**DECISION UNDER DELEGATED AUTHORITY ON AN APPLICATION
BY CHRISTCHURCH CASINOS LIMITED FOR APPROVAL OF
A NEW FLOOR PLAN FOR LEVEL 1 OF THE CHRISTCHURCH CASINO**

Date of Decision: / **November 2017**

Christchurch Casinos Limited	LEVEL 1 - Foyer Hall Option A	Date October 2017
295 MACHINES, 28 TABLES		SCALE 1:250

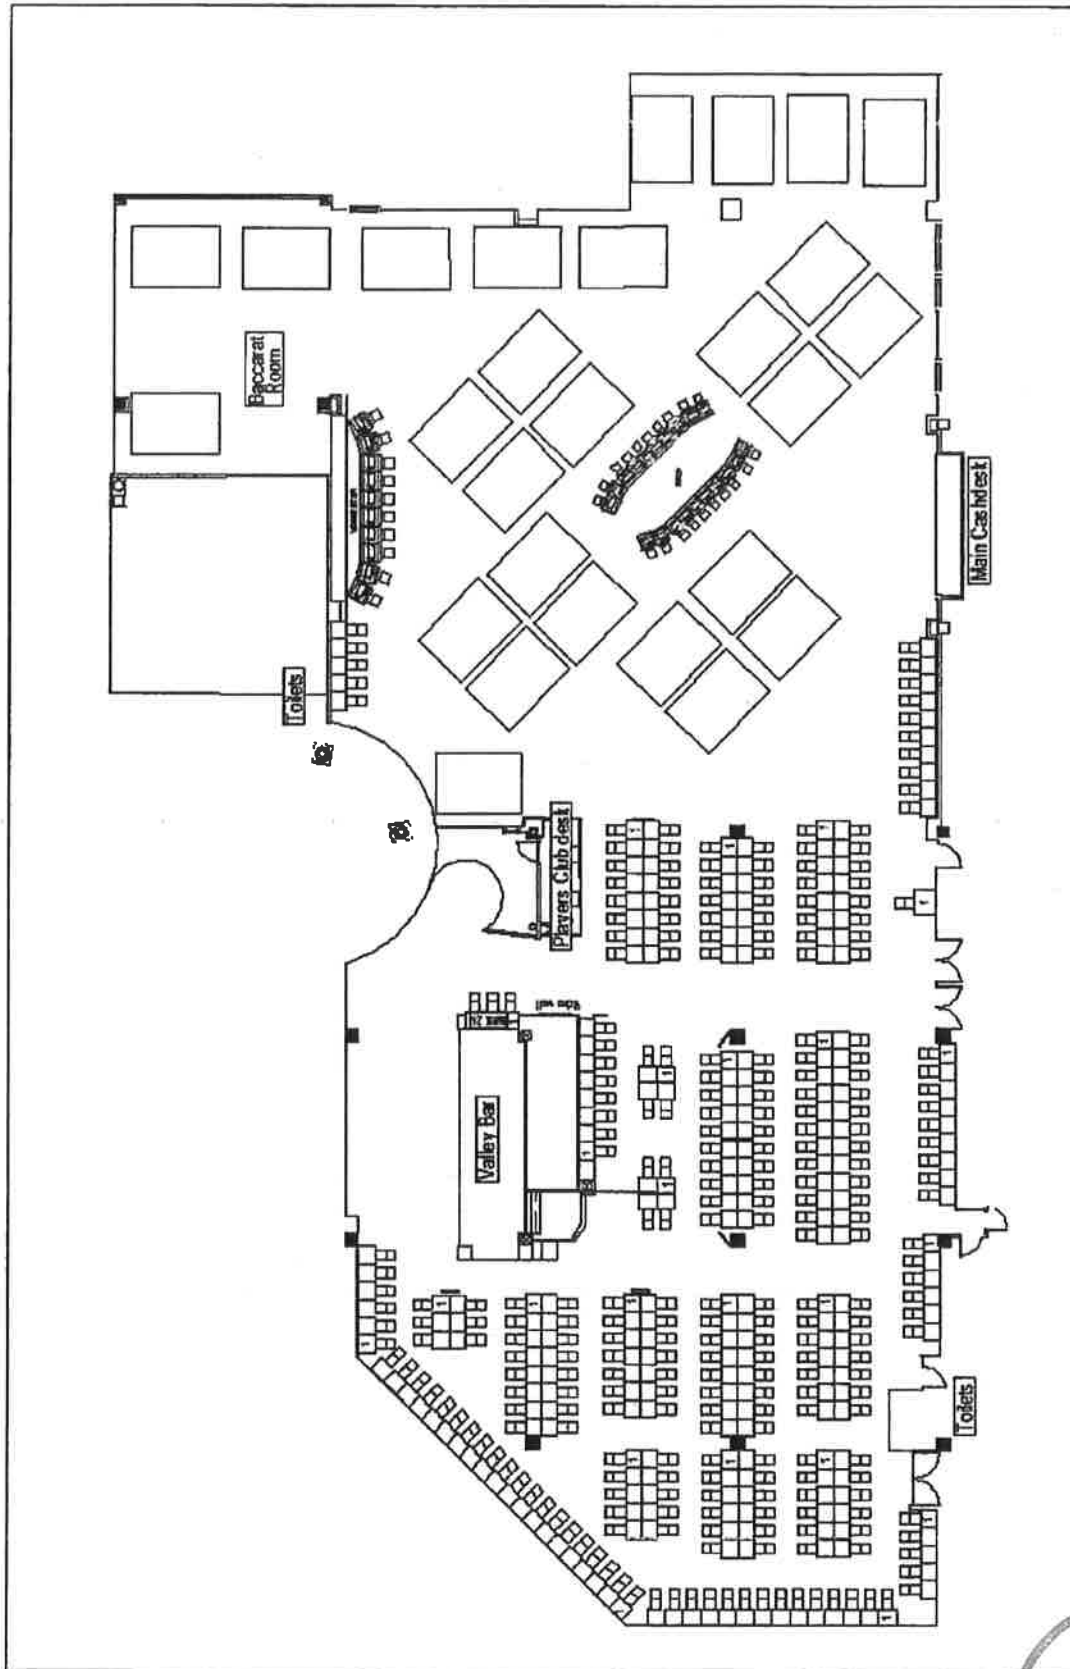
- (a) Proposed plan "Level 1-Floor plan-Option A" is currently approved as existing floor plan "2016 L1 001". In effect the floor plan is just being renamed.

- 4. The proposal raises no issues of regulatory concern for the Commission. Accordingly renamed plan "Level 1-Floor plan Option A" and new plan "Level 1 – Floor plan Option B" (attached), are approved by the Chief Gambling Commissioner and the Executive Director under delegated authority pursuant to condition 12 of CCL's operator's licence for the Christchurch casino.

- 5. Once CCL is reliant on "Level 1-Floor plan Option A", plan 2016 L1 001 will cease to be valid.

LEVEL 1 - Floorplan Option B

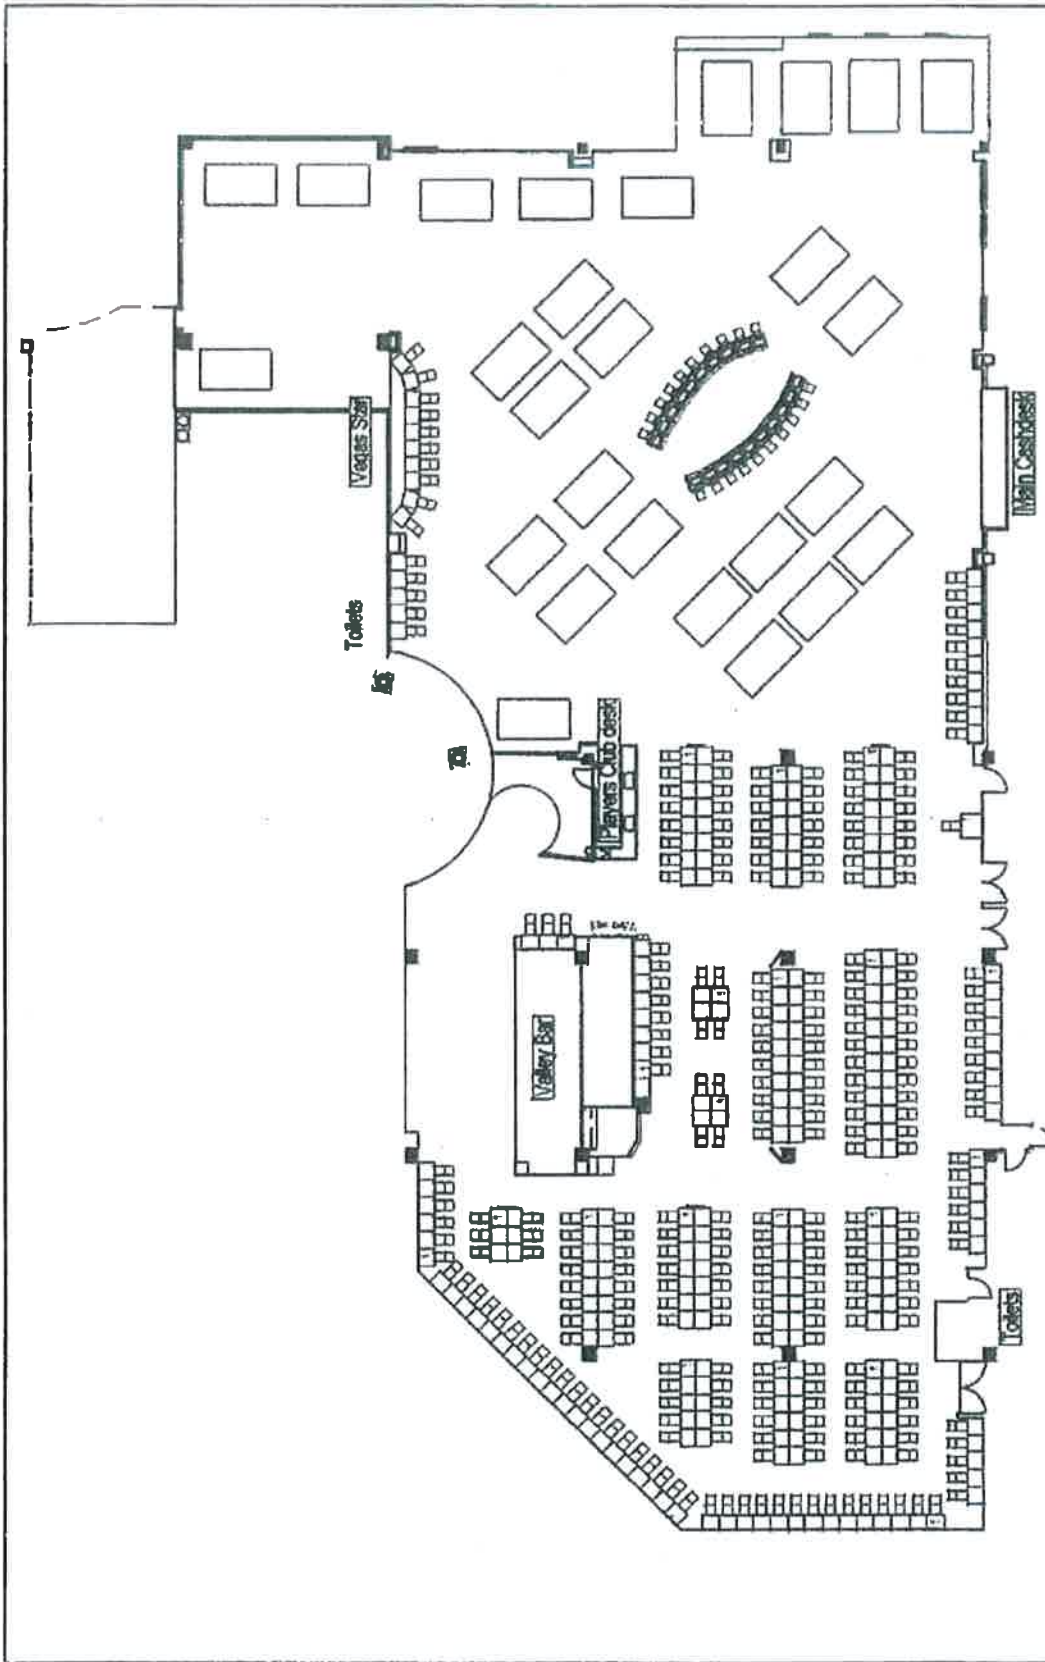
- (b) It wants the flexibility to be able to flip between "Level 1-Floor plan-Option A", that it would use when hosting Poker tournaments and a second option, "Level 1-Floor plan-Option B" which is substantively similar, but with two tables moved from the immediate Poker area into another cluster. This would mean that rather than three groups of four tables there would be one group of two, two groups of four and one group of six tables.

- (c) Reconfiguring the tables would allow it to increase the area of separation from the new Poker area when there is no tournament in play.
- (d) The CCTV layout will be revised to ensure the revised deployment complies with the requirements of the Surveillance Standard.
